Studebaker

SERVICE BULLETIN

NO. 252

1951

**ENGINE FRONT SUPPORT
MOUNTING PARTS- 10G, H**

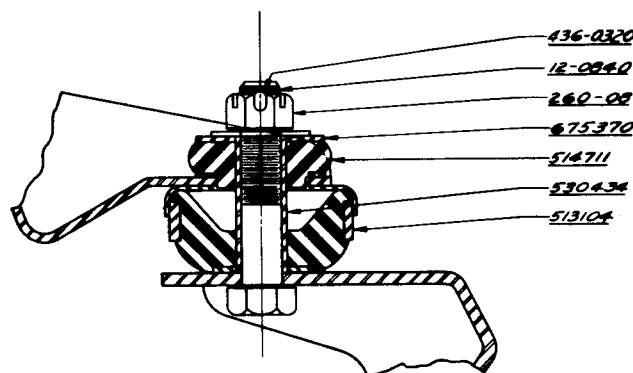
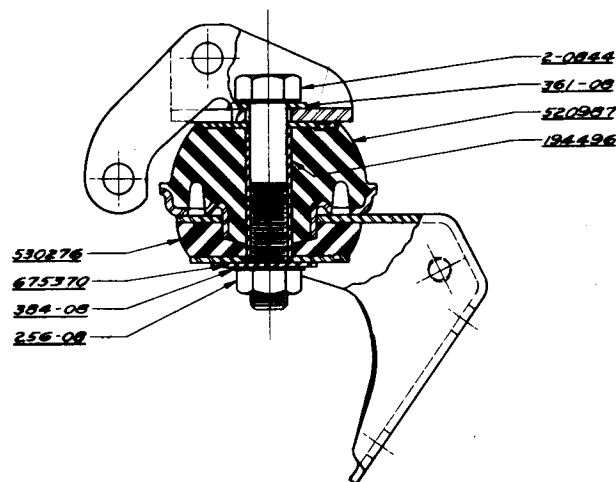
Effective with Commander Serial No. 8157444 (8953031 in Canada) and Champion Serial No. G-1062400 (G-731880 in Canada), the method of attaching the engine front support mountings conforms to the drawings at the right.

The new parts used for the Model H Commander replace the Marsden nut previously used and are as follows:

The new parts used for the Model 10G Champion replace the standard type lock washer and nut and are as follows:

Where experience on cars produced before the above serial numbers has shown that the engine front support bolts and other parts have come loose during shipment or operation, the new parts listed above can be installed as shown in the drawings at right. The Marsden nut on Commander models and the original lock washer and nut on Champion models may be discarded.

Part No.	Part Name	For Model
675370	Plain Washer	H
384-08	Shakeproof Washer	H
256-08	Nut	H

Part No.	Part Name	For Model
436-032	Cotter Pin	10G
12-0840	Screw	10G
260-08	Castellated Nut	10G

RIGHT VENT CONTROL OPERATION - 10G, H

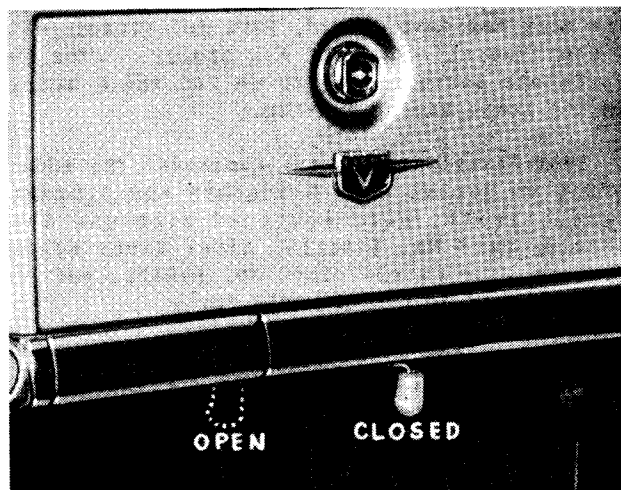
A new type of control for smoother operation of the outside right cowl vent door (on Left Hand Control cars) entered production with the following body numbers:

The new control is located just below the package compartment and is mounted to the underside of the instrument panel. It is a lever type control equipped with a knob (see

illustration) for ease of operation.

To open the vent door, move the lever to its full left position. To close the vent door, move the lever to its full right position.

The new control requires different vent door and attaching parts, so that it is necessary to order parts for service of the outside right cowl vent door or its operating control by body number.

ACCELERATOR CROSS SHAFT BRACKET REINFORCEMENT - 2R5, 2R6, 2R10, 2R11

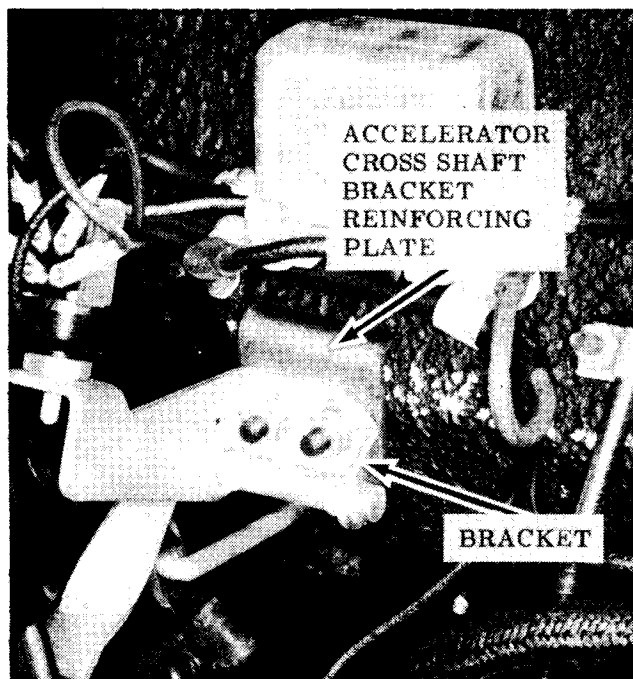
To prevent the possibility of the accelerator cross shaft bracket from becoming embedded in the insulation material on the front of the

firewall and thereby making inoperative the kickdown switch on overdrive equipped 2R Series trucks, a reinforcement plate, Part No. 680727, has entered production effective with truck Serial Nos. R5-74940, R6-2599, R10-30498, and R11-2356.

To install the reinforcing plate on trucks with overdrive transmissions before above serial numbers, remove and discard the original cross shaft bracket bolts and insert the reinforcing plate between the bracket and the firewall with the radius on the reinforcing plate uppermost (see illustration). Then install two Part No. 2-0414 bolts, using the original lock washers and nuts.
